ADDENDUM 3_October 24, 2025

RE: Addendum No. **Three (3)** to the Bidding Documents for:
Air Handler Replacements – York and Gardiner Maintenance Facilities

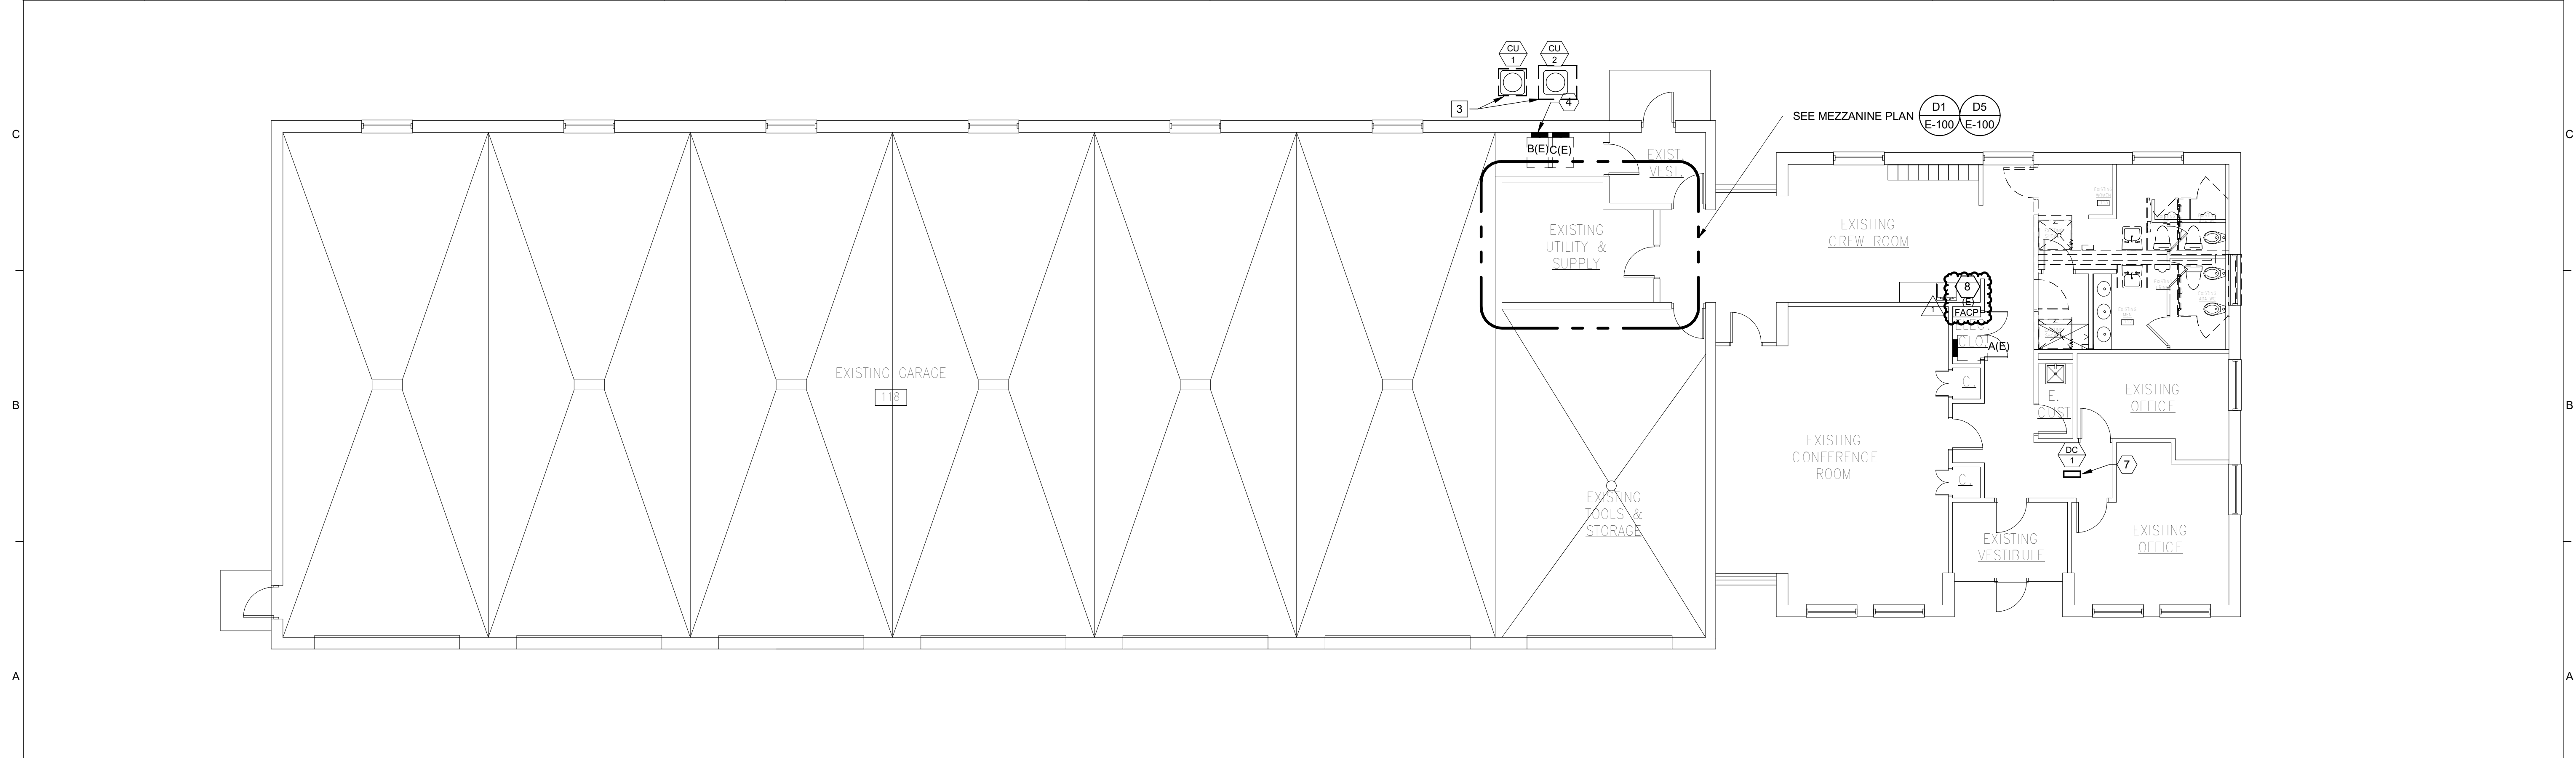
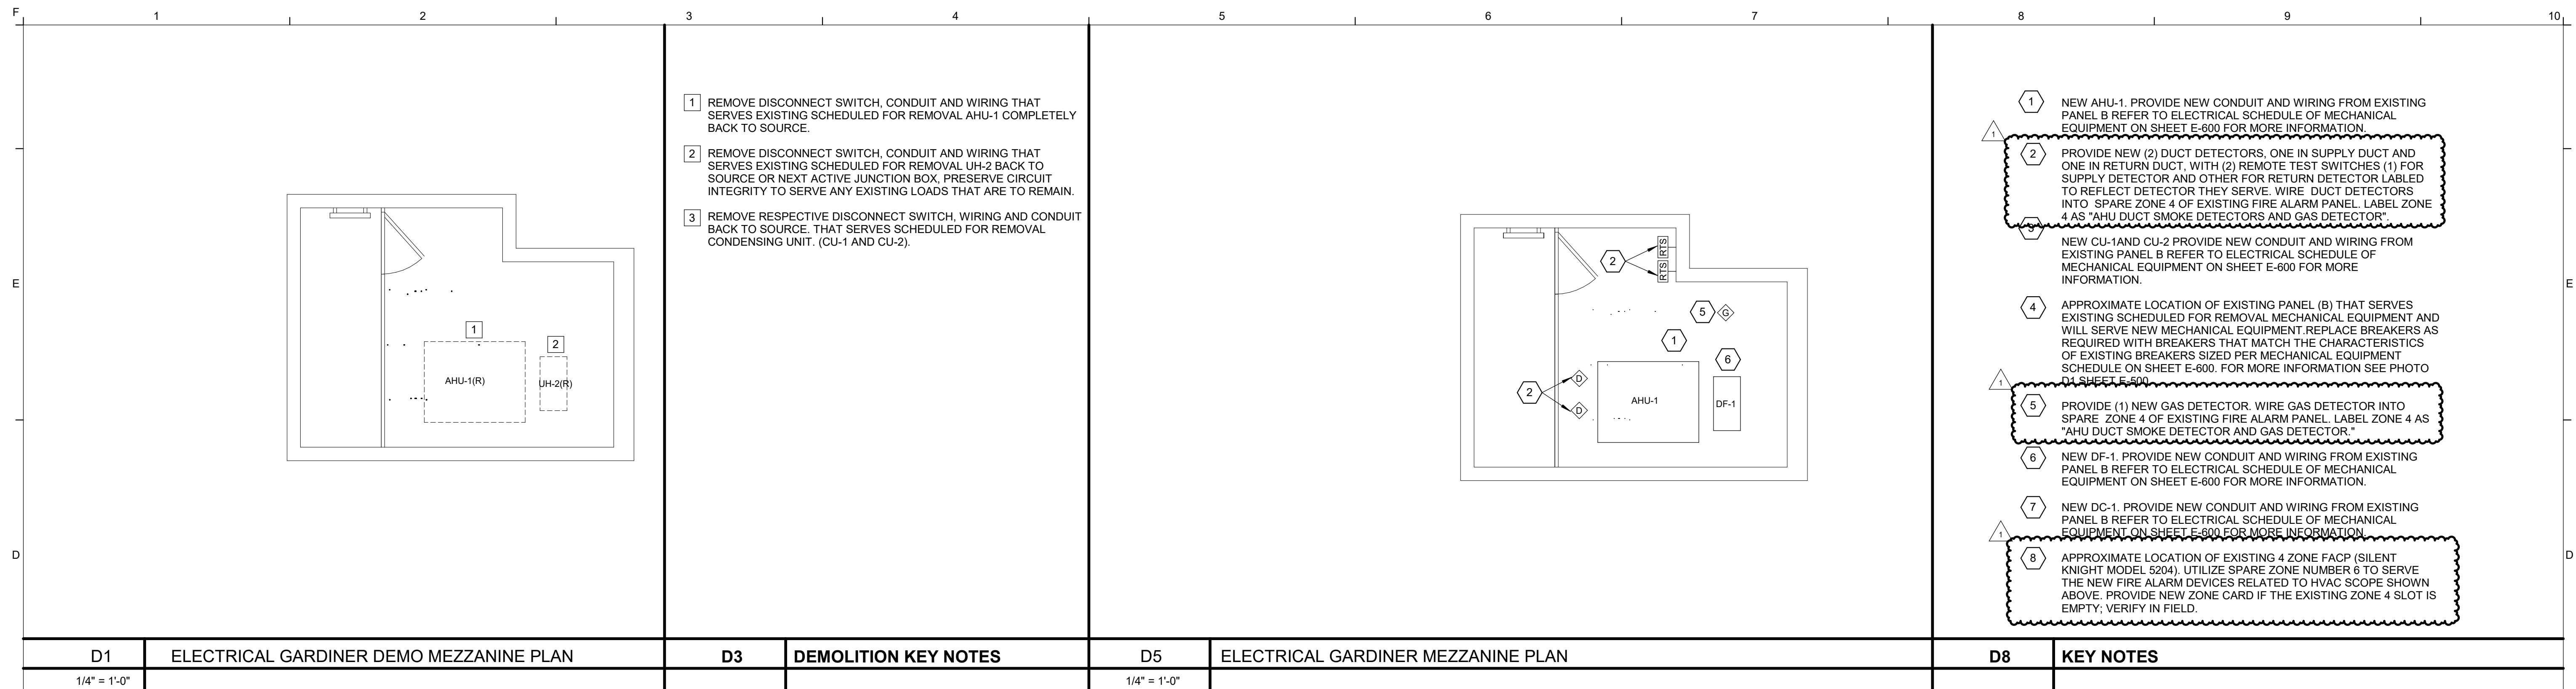
1. We have learned that the fire alarm panel (system) in the Gardiner facility cannot be expanded to accommodate the required added detectors (two smoke and one gas). Our understanding from the Fire Alarm vendor, is that this panel can be upgraded to a "conventional zoned" panel, so existing devices do not have to be changed to be addressable. Please advise.

1. Sheet 10 of 13 – E-100 – Electrical Gardiner Plan: **DELETE** the sheet in its entirety. **ADD** in its place, Sheet 10 of 13 – E100 – Electrical Gardiner Plan, attached reissued with revisions.
2. Sheet 11 of 13 – E-101 – Electrical York Plan: **DELETE** the sheet in its entirety. **ADD** in its place, Sheet 11 of 13 – E101 – Electrical York Plan, attached reissued with revisions.

Response: Yes, the FACP at both locations is a (4) zone (non-addressable panel). With that said, however, it appears that each of the panels has one spare zone. Where Gardiner has (3) new FA devices called for ; (2) duct smoke detectors (with RTS) and (1) gas detector, we recommend wiring the new devices to the spare zone in the panel. Similarly, we recommend a new gas detector at York, wired to the current spare zone. Refer to Changes to the Drawings and Changes to the Specifications herein for revisions to the contract documents to facilitate this upgrade.
